# ESCAPADE™

MX 30cc

## TECHNICAL NOTICE

### Page 7, step 11 - Installation of the Aileron Control Horns

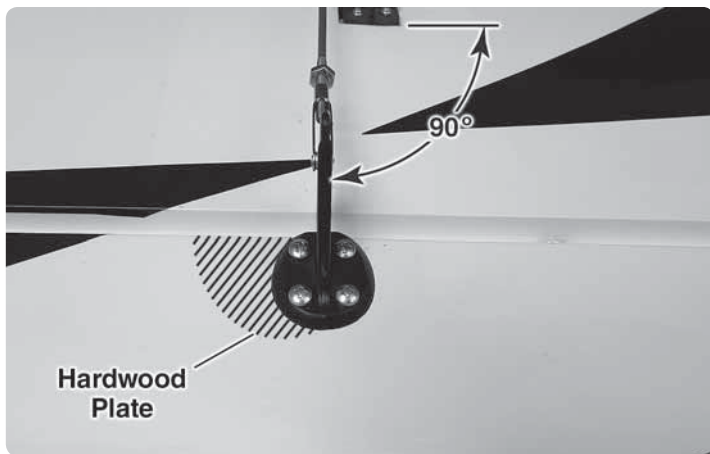
If two of the four mounting holes for the aileron control horn do not line up on the hardwood plate, follow the instruction for drilling the holes. Install the four #4 x 5/8" [16 mm] sheet metal screws. Then, remove the screws and apply a couple of drops of thin CA in each hole and allow the CA to soak into the wood and harden. Reinstall the four screws. This will securely hold the four screws. However, if you are concerned with the two screws that are not in the hardwood plate pulling out, before reinstalling them put a couple drops of 6-minute epoxy in the screw holes and then install the screws before the epoxy cures.
